## **Addendum No. 2**

**Project:** Taxiway Rehabilitation and Electrical Improvements

**Airport:** Texas Gulf Coast Regional Airport

**KSA Project No.:** 103006

4 PULLBOX BURIAL DETAIL - IN TURF  
EL510 SCALE: N.T.S.

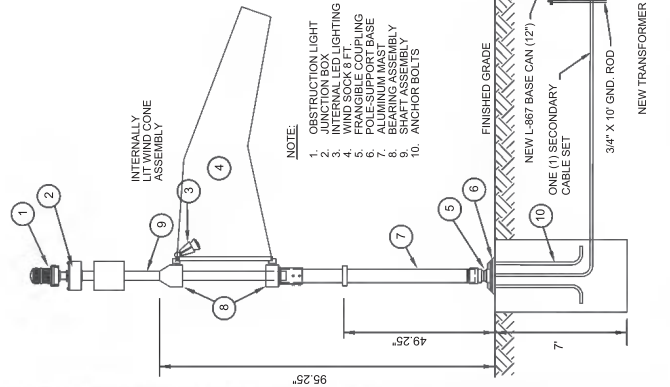
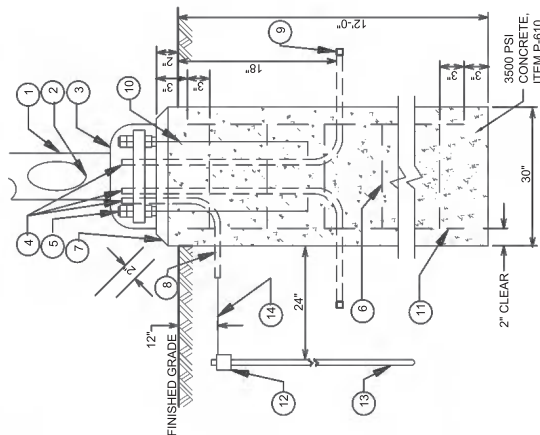
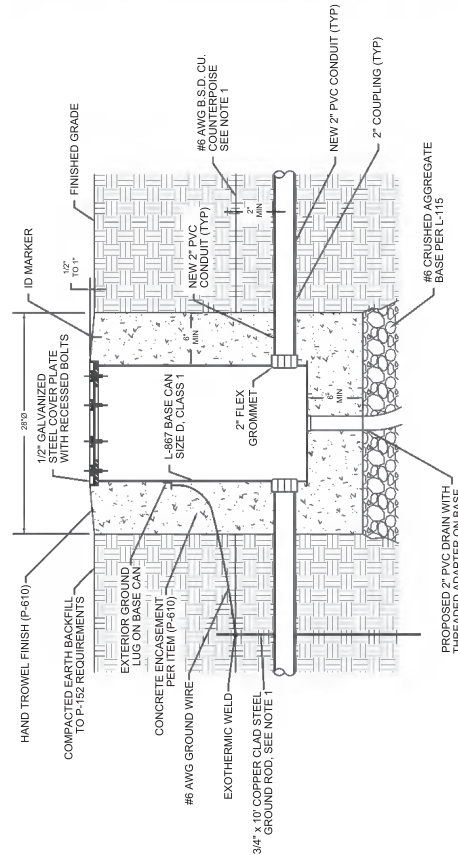
46. Question: Reference Drawing EL402, Detail 3: Is the contractor responsible for the installation of the new wooden power pole with 2" conduit riser, 2" underground raceway and junction structure?

Response: Refer to 4/EL510 for the detail for this structure. This structure will be furnished and installed by the contractor. Sheet EL510 has been revised and is included with this addendum.

Response: Please refer to detail 4 on the revised sheet EL510 included with this addendum.
